MEMORANDUM

REVIEW TYPE: **Site Plan Review**
 CASE #: **820060050**
 PROJECT NAME: 5420 Edson Lane
 APPLYING FOR: Approval of 13,150 square feet of general office on 0.679 acres
 REVIEW BASIS: Div. 59-D-3 of Montgomery County Zoning Ordinance

ZONE: C-T (Commercial Transition)
 LOCATION: Located on the south side of Edson Lane, 500 feet west of the intersection with Rockville Pike
 MASTER PLAN: North Bethesda/Garrett Park Master Plan
 APPLICANT: Edson Land Associates, LLC
 FILING DATE: September 20, 2005
 HEARING DATE: July 6, 2006

Site Plan stamped by M-NCPPC on June 15, 2006

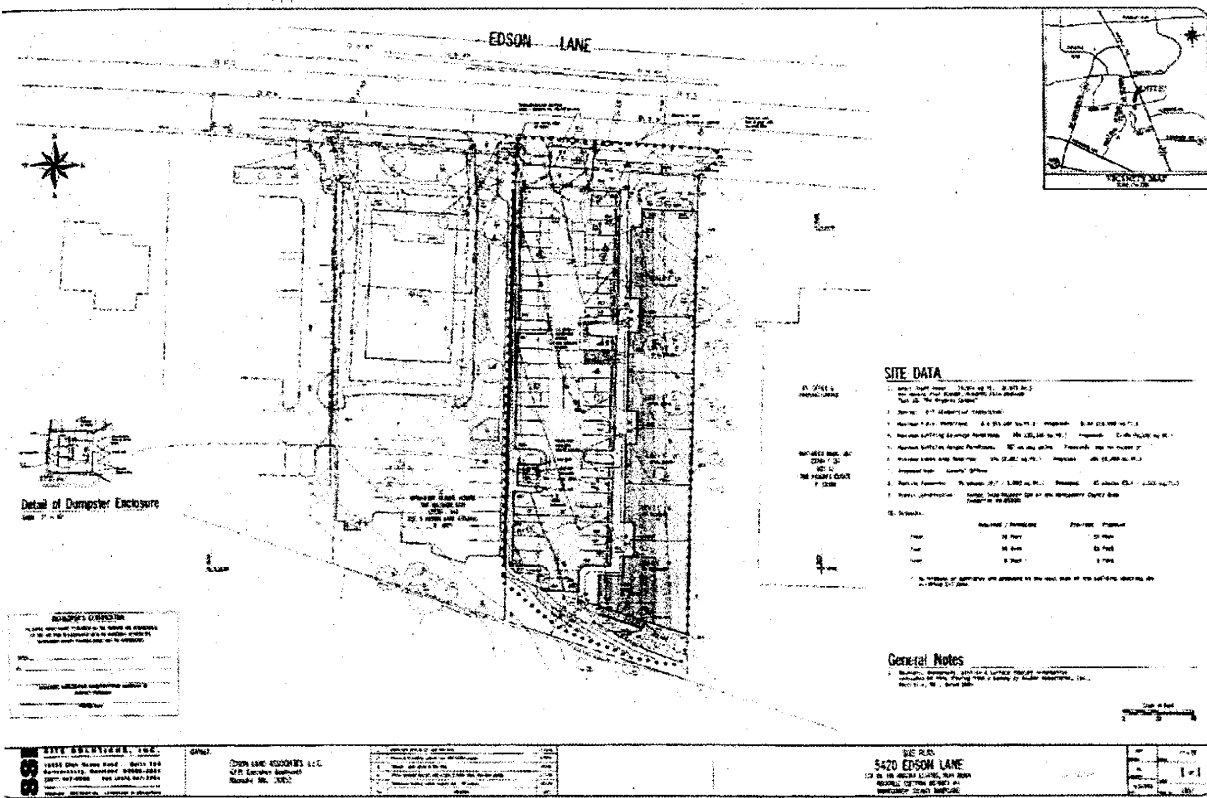
The buildings are proposed to be 35 feet in height, stepping down to approximately 20 feet in height for the southernmost office unit to provide compatibility and a sense of scale to the adjacent residential property.

1. Preliminary Plan Conformance
 The proposed development shall comply with the conditions of approval for Preliminary Plan No. 11996015A.
2. Site Design
 - a. The height of the southern portion of proposed Unit F shall not exceed 20 feet, as shown on the attached Exhibit 1 in Appendix C. The 20 foot height is measured from elevation 350.00 as shown on the site plan dated June 15, 2006.
 - b. The dumpster receptacle, location, and its enclosure shall be installed as shown on the site plan stamped on June 15, 2006 by the M-NCPPC and depicted as "Detail of

- c. The HVAC compressors on the southern end of the proposed building shall be residential type compressors.

Provide additional foundation planting along the frontage of the building, similar to the proposed plantings in front of Units A and F.

- a. Provide a five-foot-wide sidewalk and 10-foot-wide lawn panel along the Edson Lane property frontage.
- b. Provide a 4-foot-wide sidewalk from the eastern portion of the proposed parking lot to the five-foot-wide sidewalk within the Edson Lane right-of-way.

Exhibit 1-Illustrative View of the proposed building

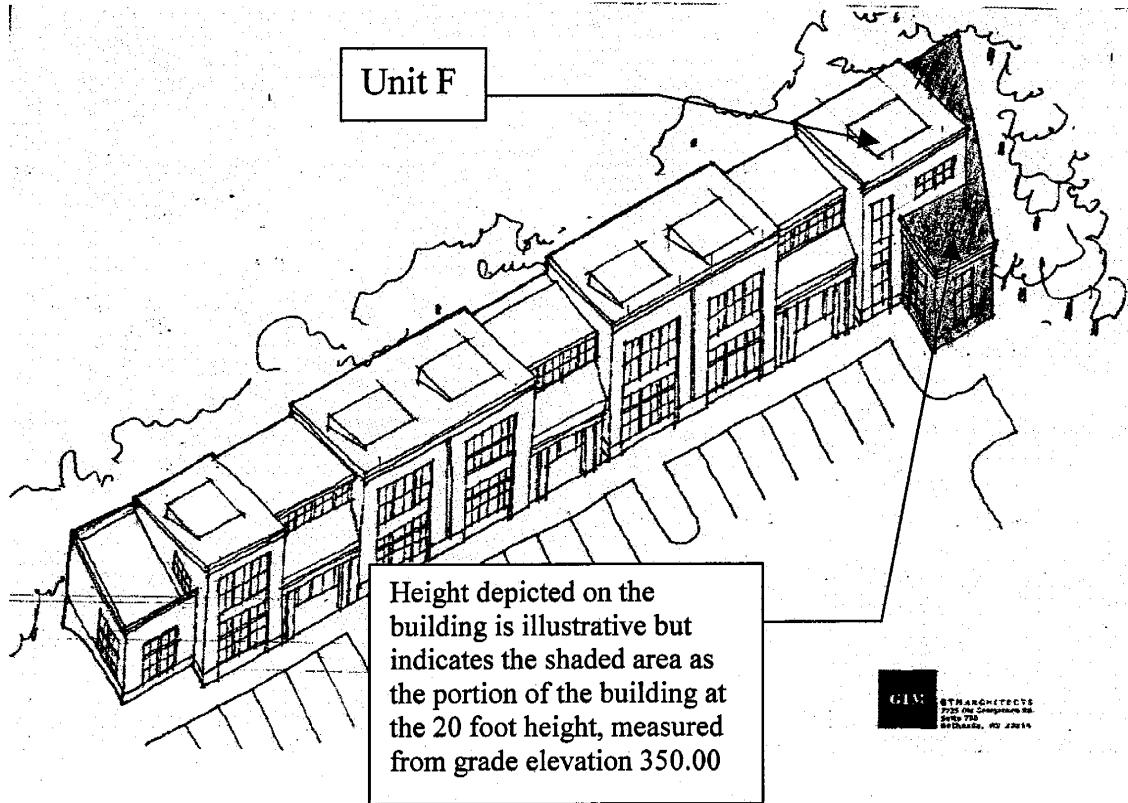
3. Building Height – The building height at its southern end will no higher than 20 feet measuring from elevation 350.
4. Lighting – The lighting as shown and described on the Landscape and Lighting Plan prepared by Site Solutions, Inc., dated June 1, 2006, is acceptable. The lighting will be directed away from the single-family detached dwellings in the Wickford Subdivision.

Zoning Ordinance Development Standard	Proposed for Approval
Min. Tract Area (sf.):	12,000	29,574
Net Site Area after dedication (sf.):		29,574
Max. Floor Area Ratio (FAR):	0.50 (14,787 s.f.)	0.44 (13,150 s.f.)
Min. Building Setbacks (ft.)		
from any street right-of-way as shown on master plan (Edson Lane)	10	20
from any other lot line:		
adjoining lot in a residential zone and not recommended for commercial or industrial zone	15	25
eastern boundary	0*	0*
western boundary	15	53 (from a portion of unit F as shown on the site plan stamped June 15, 2006) 67 (for units A-E and a portion of unit F as shown on the site plan stamped June 15, 2006)
Max. Building Coverage (%): (for a lot with an area of 12,000 sf. or more [59-C-4.303(b)])	35 (10,350 sf)	31 (9,100 sf)
Min. Green Area (%):	10 (2,957 sf)	28 (8,290 sf)
Max. Building Height (ft.): (for a lot with an area of 12,000 sf. or more [59-C-4.303(b)])	35 at any point	35 at any point (as measured From the street grade opposite the middle of the front of the building, except for a portion of Unit F, which shall not exceed 20 feet from elev. 350.00 as shown on Exh. 1 (Appendix C)
